Construction Traffic Management Plan – Aerotropolis Station

SMWSASSM-PLD-AEC-TF-PLN-000001

Parklife Metro D&C

Traffic Management Road Safety Audit Report

FIGURE 10: PROJECTED AEC HV NUMBERS

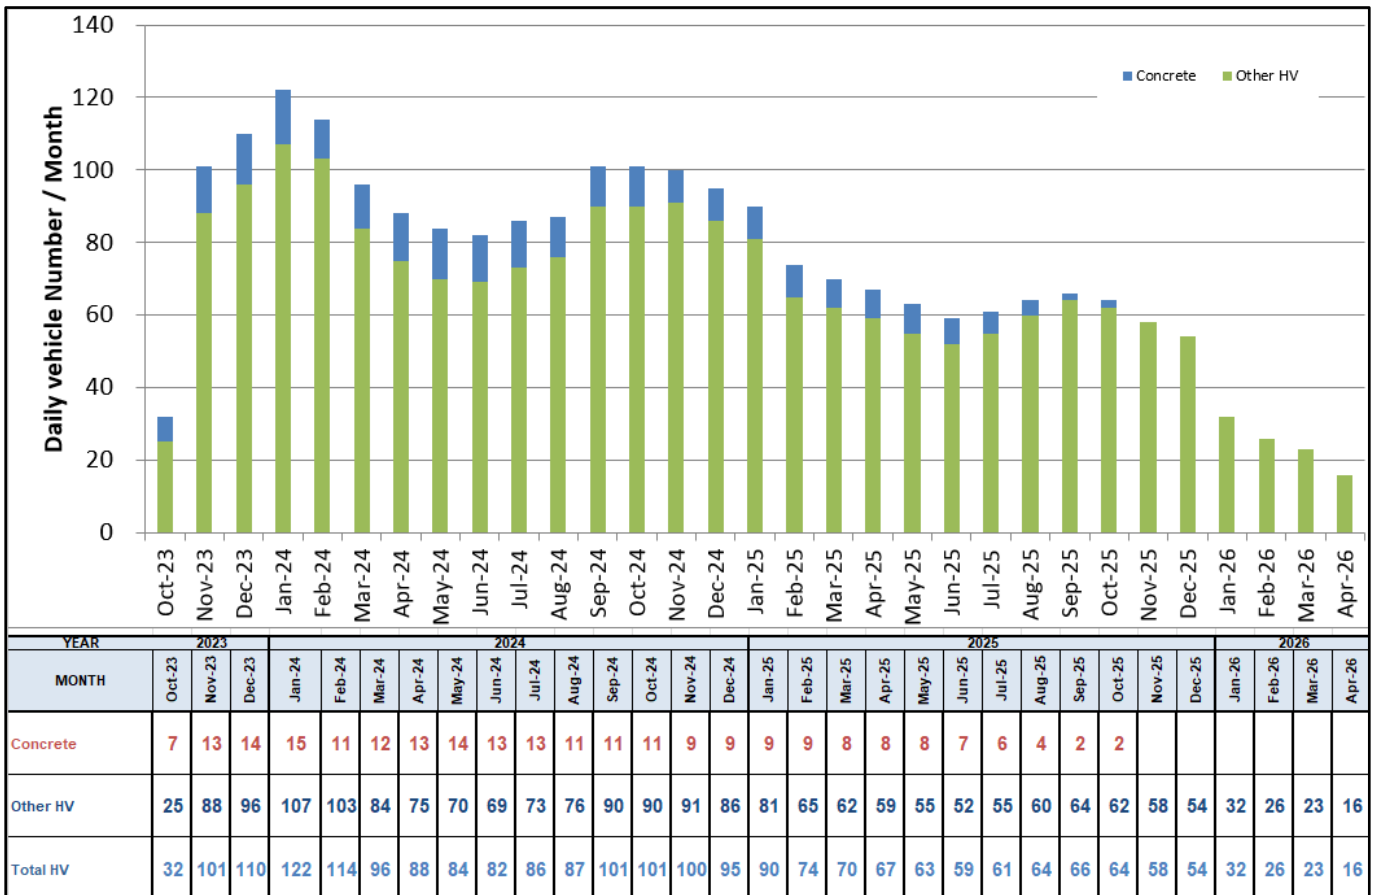
21	31/08/2023	TFN	TNG	SMWSASSM-PLD-AEC-TF-PLN-000001	4.5.1_Fig. 10 & 5.1	NA	Is this chart includes concrete transporting agitator vehicles in-between ABP & AEC ? If YES, what is the possibility of updating the Fig. 10 to show (in different colours) concrete agits? This representation will allow the reviewers and the team to understand impact on road network due to long distance travelling AVs and short distance AVs.(i.e. Concrete Agits) seperately.	Observation		N
	12/09/2023	PLD	WZHENG	SMWSASSM-PLD-AEC-TF-PLN-000001	4.5.1_Fig. 10 & 5.1	NA	The volumes presented in Figure 10 include concrete agitator trucks. Figure 10 has been updated to show the split between concrete HVs and all other HVs.	Observation		N

Appendix B Q-TA1 Signage Plan

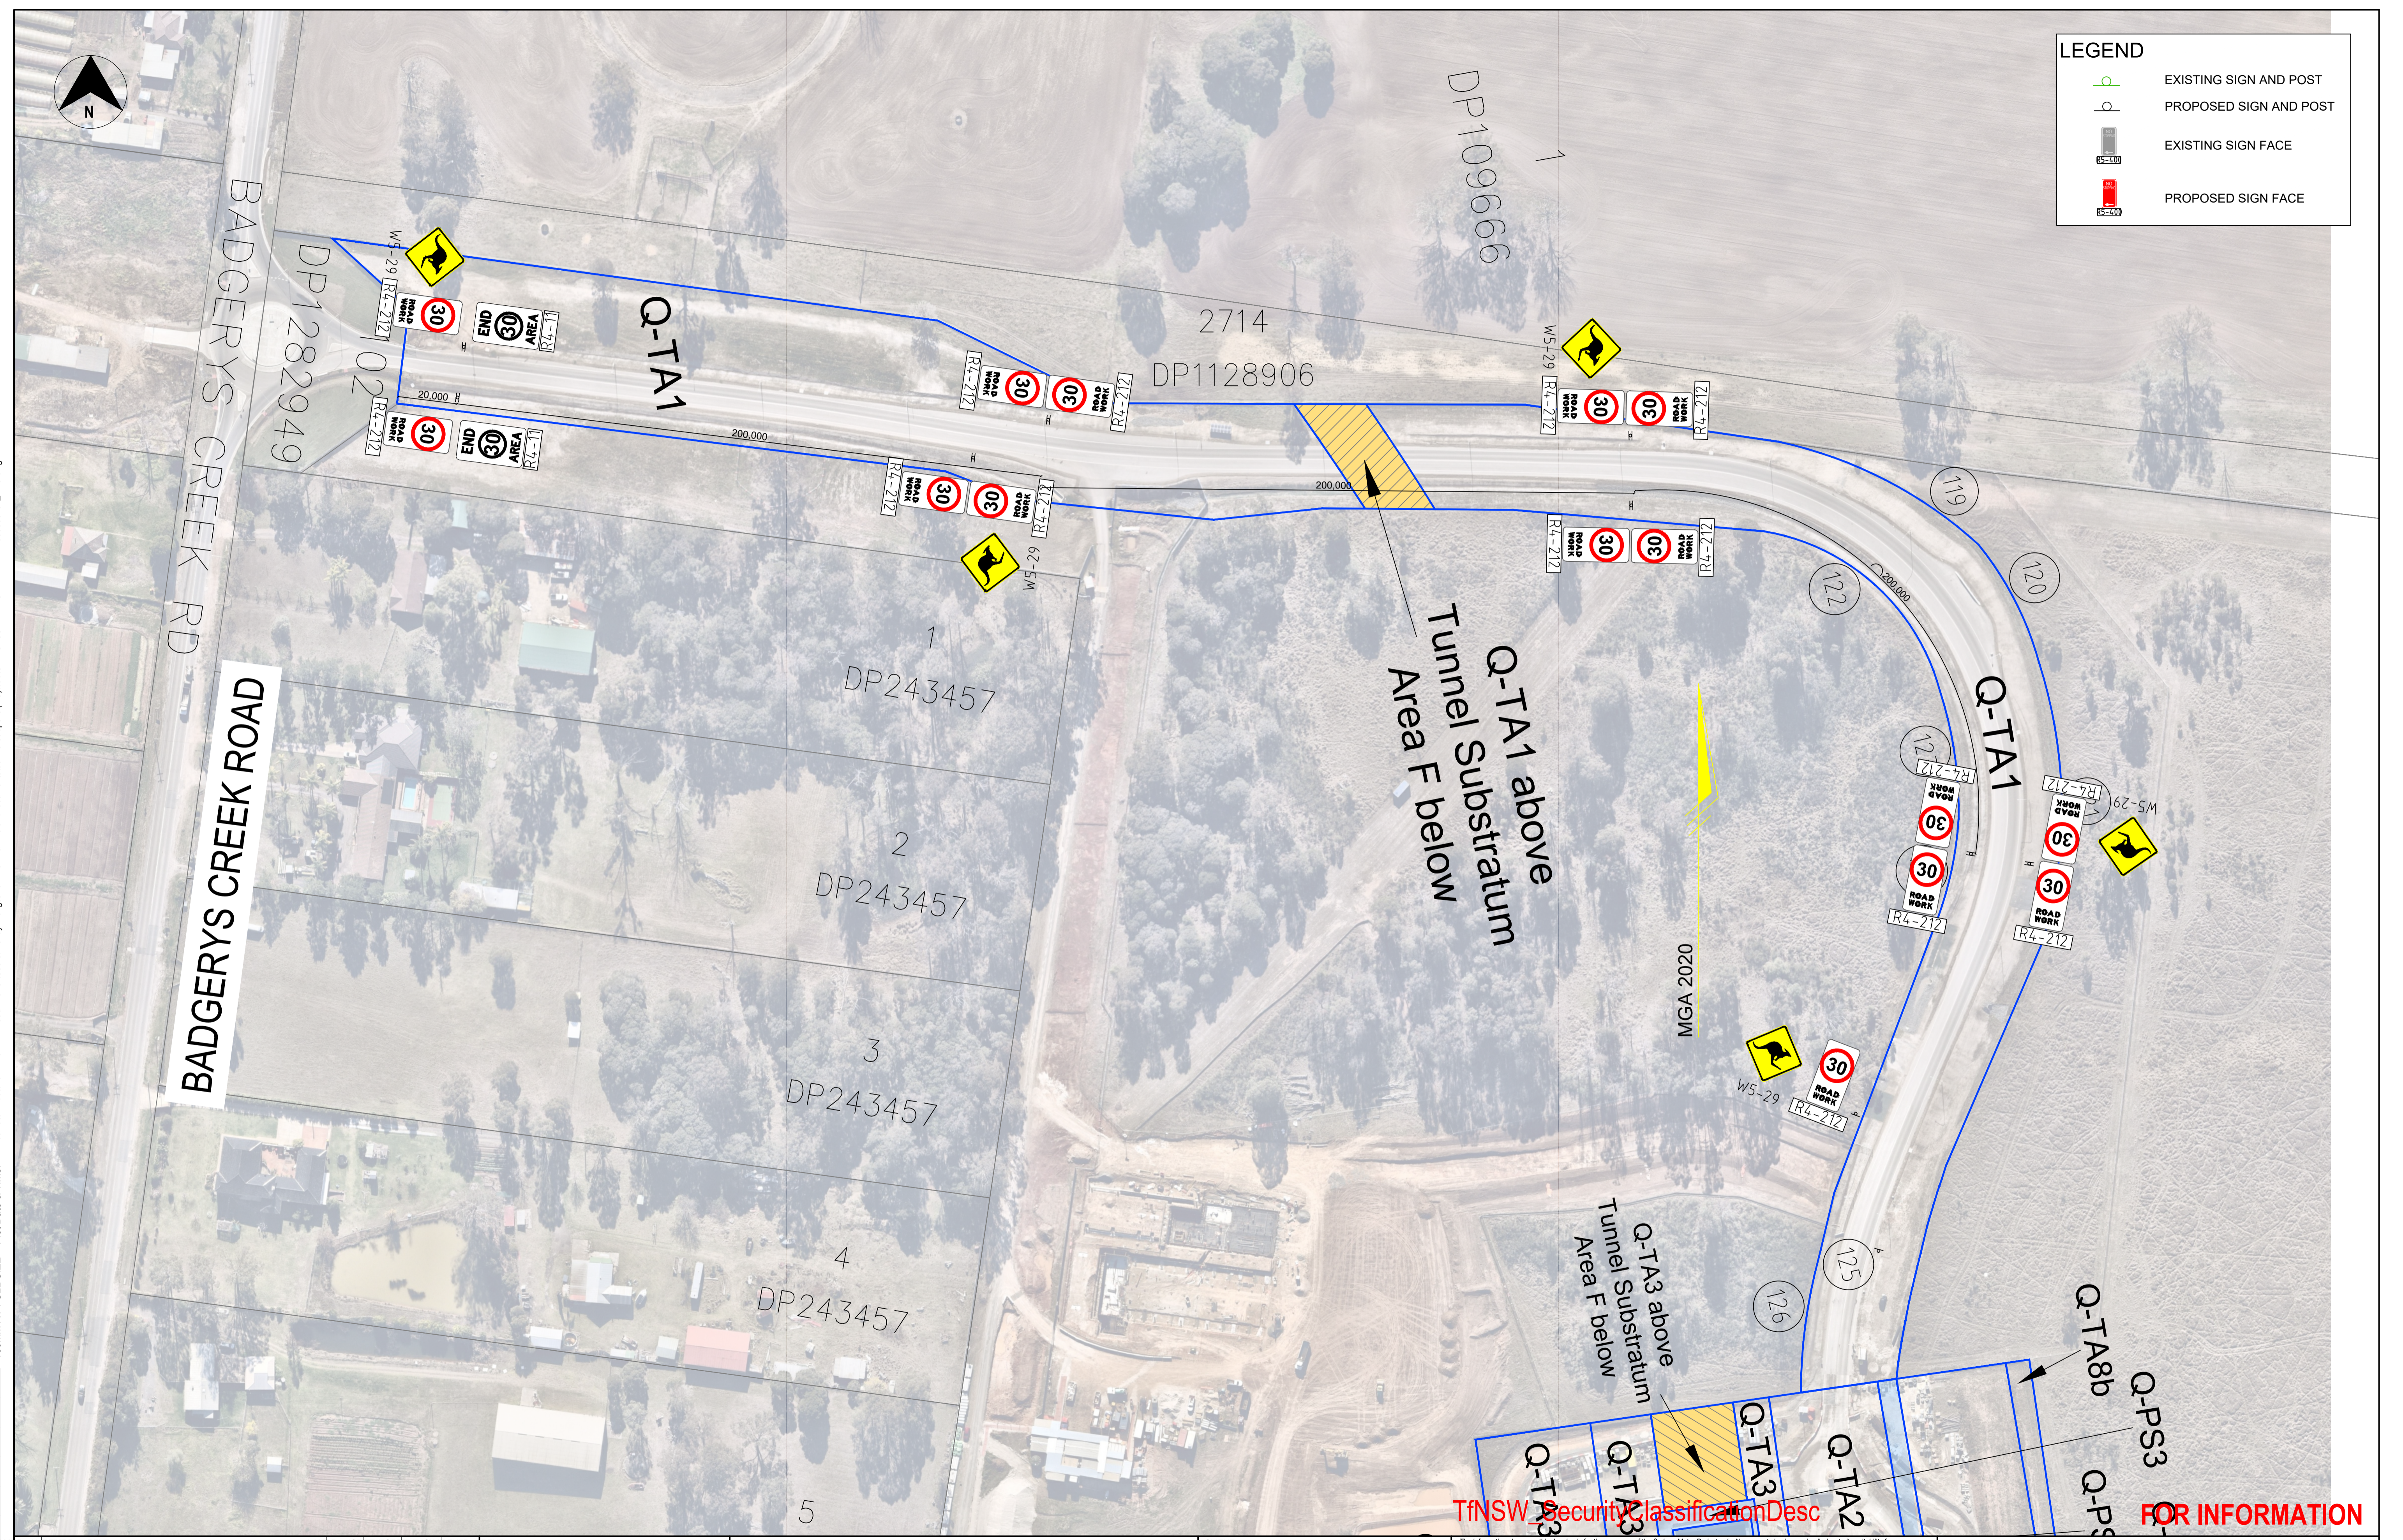
25	31/08/2023	TFN	TNG	SMWSASSM-PLD-AEC-TF-PLN-000001	Apendix B_Signage Plan	NA	As Badgery Creek speed limit might not be 40km/h, Isn't it require to use to different sign/speed to notify the vehicles existing Q-TA1 to Badagery Creek roundabout to comply?	Observation		N
	12/09/2023	PLD	WZHENG	SMWSASSM-PLD-AEC-TF-PLN-000001	Apendix B_Signage Plan	NA	Signage plan has been updated to reflect the end 40km/h speed zone for vehicles exiting Q-TA1.	Observation		N

1.2. The Signage Plan in Appendix B shows 40 km/h road work speed zone signs to be implemented along the Q-TA1 haul road.

There are existing 20 km/h signs on the haul road. The report indicates this will be replaced with the 40 km/h speed zone signage. However, the plan does not indicate the 20 km/h signs to be removed.

There is a small risk that the removal of the 20 km/h signs is missed. The mixture of 20 km/h and 40 km/h will create confusion to motorists.

12/09/2023	PLD	WZHENG	SMWSASSM - PLD - AEC - TF - PLN - 000001	Appendix B - Q-TA1 Signage Plan	NA	Please refer to the updated signage plan for details of the end of 30km/h proposed. The start of the 30km/h sign has been placed in accordance with TCAWS 6.1 along Q-TA1. Given the speed zone is a temporary speed zone along a private haul road, installation of 30km/h pavement marking is not a requirement of TCAWS 6.1 and will not be provided.	Minor Non-Compliance		N
20	31/08/2023	TFN	TNG	SMWSASSM-PLD-AEC-TF-PLN-000001	Section 4.5.1	NA	Does the demand profile in Figure 7 include the SBT/SCAW demands? If excluded: 1. Any insights when the SCAW access will be required, and the associated construction demands? 2. Advise the construction demands during the 20-week TBM retrieval.	Observation		N
	12/09/2023	PLD	WZHENG	SMWSASSM-PLD-AEC-TF-PLN-000001	Section 4.5.1	NA	It is noted that the demand profile in Figure 10 of Section 4.5.1 of the CTMP is for SSTOM only. SCAW do not have any access or works at Aerotropolis. SBT plus SSTOM demand during TBM retrieval will be documented by SBT in their Aerotropolis CTMP upate, as outlined in Section 1 and Section 5.5	Observation		N

SSTOM Traffic Team to conduct inspection post implementation to ensure 20km/h signs are removed and 40km/h speed limit sign installed per signage plan.
